# Digital Advertising Sign – Lane Cove Overpass

Development Application Assessment DA 23/2902 (PAN-310940)

September 2023

Published by the NSW Department of Planning and Environment

**Figure 5 | Elevation** (source: Applicant's Engineering Plans)

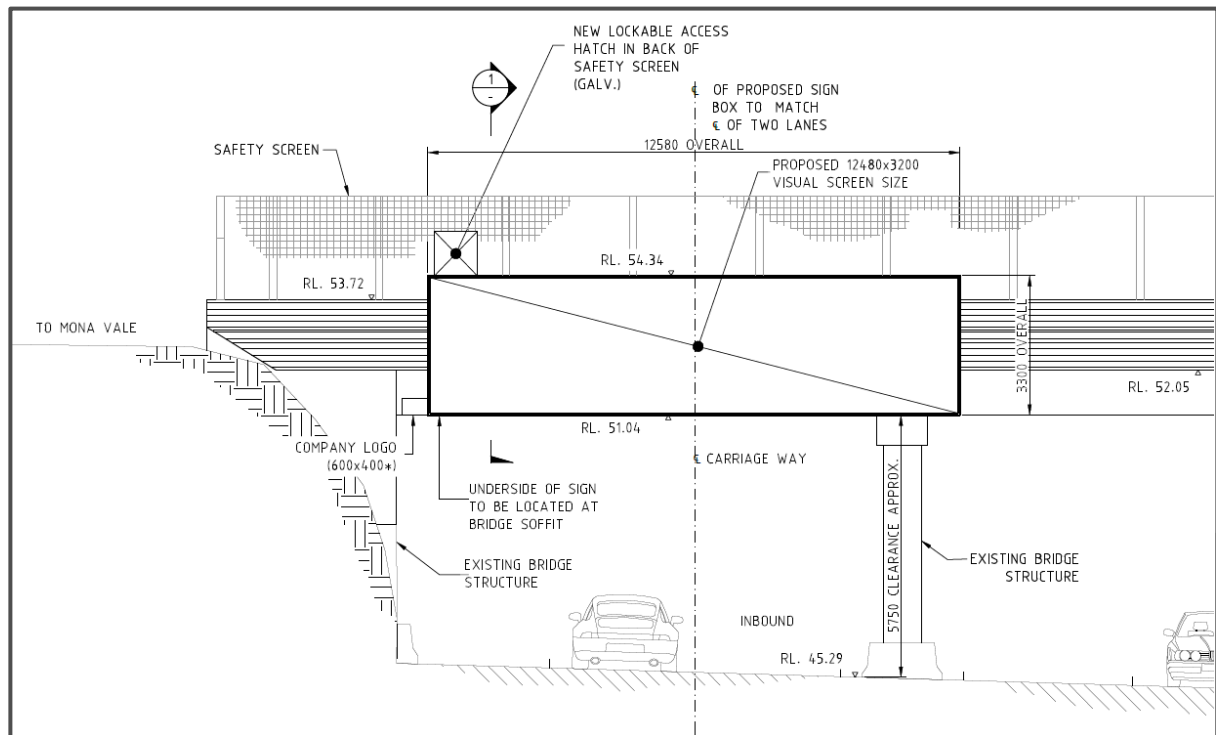
- logo should be located within the advertising display area to comply with Clause 3.18 of the IE SEPP.
- plans provided indicate the vertical clearance proposed is less than 5.8 m

As discussed in **Section 4.4**, Council raised concerns the sign would reduce the vertical clearance to less than 5.8 m. Council recommended a condition of consent be imposed requiring the sign is designed and installed in accordance with the IE SEPP and the Guidelines.

As part of the RtS, the Applicant advised the reference to the 5.8 m clearance requirement in the Guidelines is not applicable to the proposed sign as would not extend below the soffit of the superstructure. The RtS also included a supplementary statement from traffic engineers (Bitzios) contesting TfNSW's requirement for an anti-gawk screen on the basis that existing vegetation would block views from the off-ramp.
